# Technical Service Bulletin

<b>Subject:</b>  COOLANT LEAKS AT CYLINDER HEAD	<b>Bulletin No.:</b> 01-007/22
	<b>Last Issued :</b> 06/27/2022

This bulletin supersedes the previously issued bulletin(s) listed below. The changes are noted in Red text.

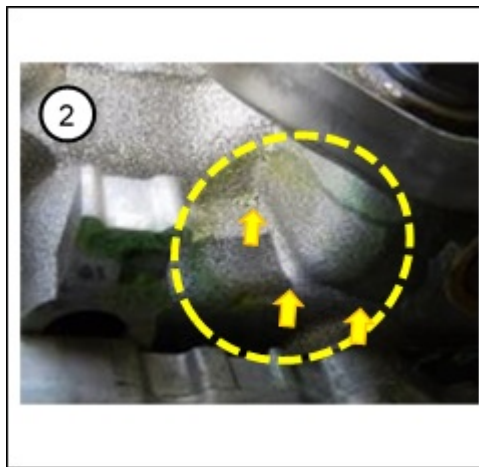
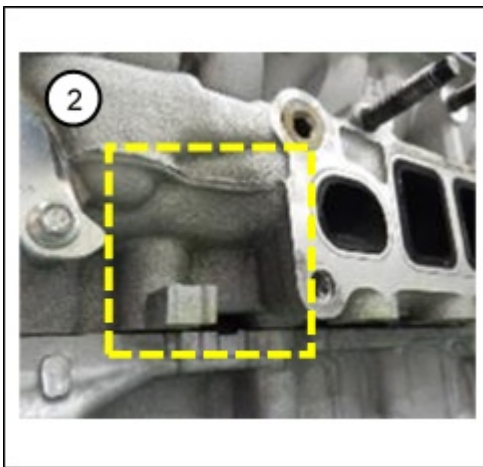
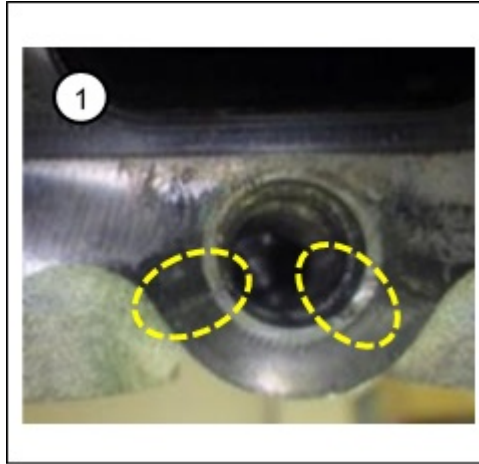
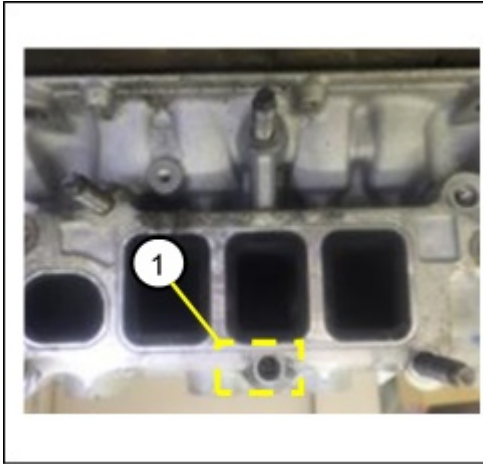
Some vehicles may have coolant leaks at the cylinder head around the exhaust manifold (as shown below). There may be cracks at the stud bolt hole (1) or at the outside of the exhaust manifold (2).

Cracks may be caused by:

- Deformation of the exhaust manifold during usage causing unexpected force to certain areas of the cylinder head.
- Residual stress generated during production in the cylinder head material may be greater than expected. The external force from the exhaust system when driving over bumps may cause unexpected force to certain areas of the cylinder head.

To eliminate this concern, the design of the exhaust manifold gasket and the cylinder head has been modified to reduce the force on the cylinder head.
